UNITED STATES PATENT AND TRADEMARK OFFICE

APPLICATION NO.	FILING DATE	FIRST NAMED INVENTOR	ATTORNEY DOCKET NO.	CONFIRMATION NO.
10/772,572	02/05/2004	Toshihiro Sawamoto	9319S-000664	2262

Office Action Summary

DETAILED ACTION

FIG. 5A (1st Interpretation)

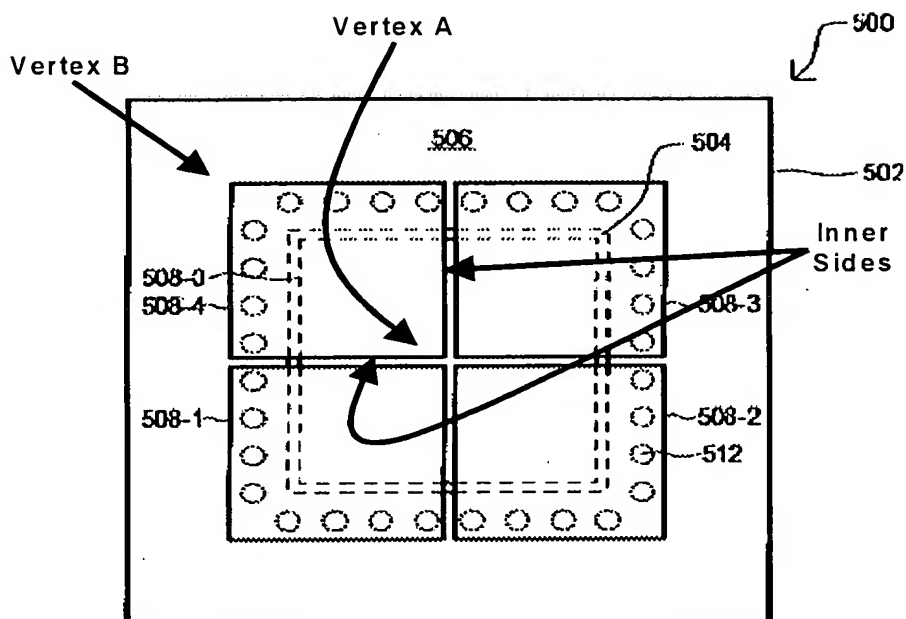
Figure 5A: First Interpretation

Regarding claim 2, Jones et al. teaches a semiconductor device, comprising:

a rectangle-shaped carrier substrate (508-4) [see fig. 5A];¹

a semiconductor chip (508-0) mounted on the carrier substrate [see figure 5A];

a region without a protruding electrode that is provided along at least two sides which intersect at a first vertex of the carrier substrate (consider the “inner sides” of the carrier substrate 508-4 adjacent to vertex A) [see fig. 5A, below]; and

a protruding electrode group (512) which is provided along at least two sides (sides opposite to the “inner sides”) which intersect at a second vertex (Vertex B) of the carrier substrate (508-4) opposite the first vertex (Vertex A) [see fig. 5A, below].

Regarding claim 5, Jones et al. teaches a semiconductor device, comprising:
a carrier substrate (508-4) [see fig. 5A]; and
a protruding electrode (512) arranged on the carrier substrate, excluded from a region where a semiconductor chip (508-0) is mounted overlapped by an end of the carrier substrate (inner sides) [see fig. 5A, above].

Regarding claim 6, Jones et al. teaches a semiconductor device, comprising:
a carrier substrate (508-4) [see fig. 5A, above];

a semiconductor chip (508-0) mounted on the carrier substrate [see fig. 5A, above];

a plurality of land electrodes formed on the carrier substrate [It is noted that connections 512 are similar to connections 312 (see col. 6, lines 42-44), which include a solder-bump flip-chip interconnection (col. 6, lines 4-5). Please note that a solder-bump flip-chip interconnection inherently includes pads (e.g. lands) which connects the bumps to the inner wiring of the device]; and

a protruding electrode (512) arranged on a pad of the plurality of land electrodes [see fig. 5A, above].

Figure 5A: Second Interpretation

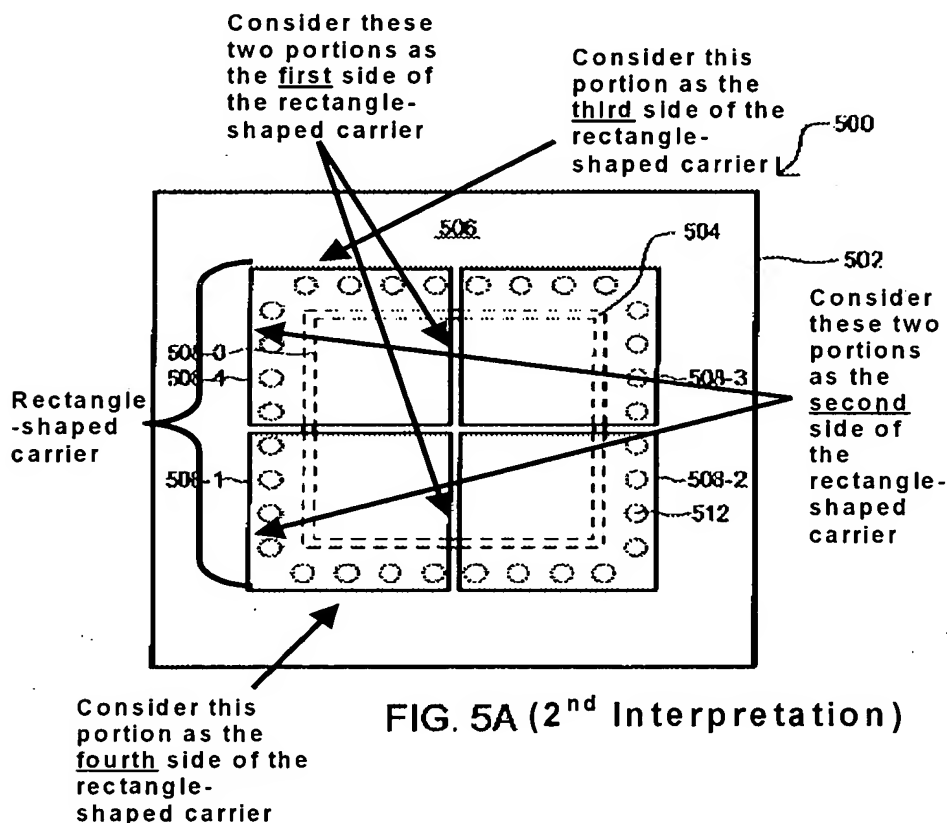
Regarding claim 3, Jones et al. teaches a semiconductor device, comprising:

a rectangle-shaped carrier substrate [consider the rectangle shaped carrier formed by the combination of 508-1 and 508-4. See fig. 5A, below];

a semiconductor chip (508-0) mounted on the carrier substrate [see fig. 5A, below];

a region without a protruding electrode which is provided along at least a first side of the carrier substrate [consider the first side as shown in figure 5A, attached below]; and

a protruding electrode group (512) which is provided along a second side of the carrier substrate opposite the first side [consider the second side as shown in figure 5A,

attached below], and along at least a third side which intersects the second side (consider the third side as shown in figure 5A, attached below).

Regarding claim 4, Jones et al. further teaches that the protruding electrode group is arranged in a U-shape (consider protruding electrodes 512 arranged along second, third and fourth sides of the rectangle-shaped carrier as shown in fig. 5A, attached above).
